FIELD SERVICE BULLETIN

FSB Number: BJCCFSB2006-347
Author: Feng Joanna
Date: July 24, 2006
Total No. of Pages: 2
Subject: **V3i Keypad Poor Tactile_Contamination on golden pad**
Model Affected: GSM V3i
Level of Repair: 2

Golden pad contamination

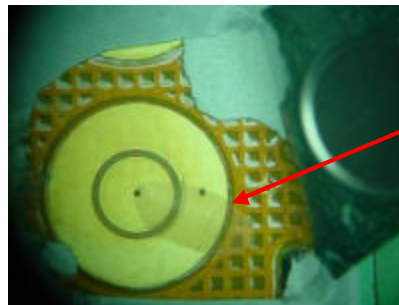
Service has been made aware of an issue identified in the PRC V3i MOL analysis. The symptom is main keypad poor tactile and can cause a customer complaint of "Main Keypad, Poor Tactile".

It is due to a contamination coming from the glue coating process. Improper pressure was given to nozzle and caused glue overflow, which contaminated the golden pad and solidified on flex surface after oven. The affected Kflex supplier is M-Flex.

1. A quality alert was immediately issued to related stations for the above issue.
2. M-Flex has phased in tactile testing with metal keypad pressing on project Siliqua#183 K-Flex from June 15, 06 on.

1. A special line leader has been assigned to verify the intensity of pressure and ensure it is between 10 to 50 PSI, at each operator's start up of each shift. If the pressure of the nozzle is found to be out of spec, the glue tube will be scrapped and a new tube will be used – 06/21/06.

2. Additional inspection to the flex surface after glue coating was added prior to the UV curing step – 06/22/06.
3. IPQC will enhance the inspection to this glue coating fixture control and the golden pad contamination and while doing first article checking and sampling checking at conformal coating station – 06/22/06.
4. Require the PSA lay-up line to clean the entire flex surface using a no-dust cloth and alcohol to wipe off the flex surface before pasting EL panel and ensure the cleanness of the surface prior to pasting the el Panel. This will also aide in feeling any raised surface on the dome pads. Operator's are also required to perform a 100% check of the surface after cleaning – 06/22/06 (Week 25, Year 2006).

M-Flex ID: 54067

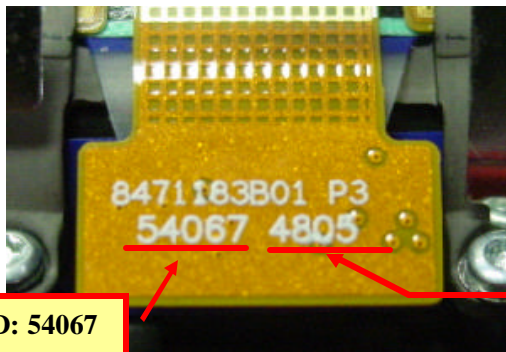
When servicing any V3i customer return with described issue, check the Kflex Date Code firstly. If it is Mflex's and Date Code before 2506 (= Week 25, Year 2006), replace the Kflex. The part No. is 8471183B02. Otherwise, please follow normal troubleshooting procedure on this unit or send it to Motorola for further analysis.

Date Code: 4805 = Week 48, Year 2005
CA Date Code: 2506 = Week 25, Year 2006
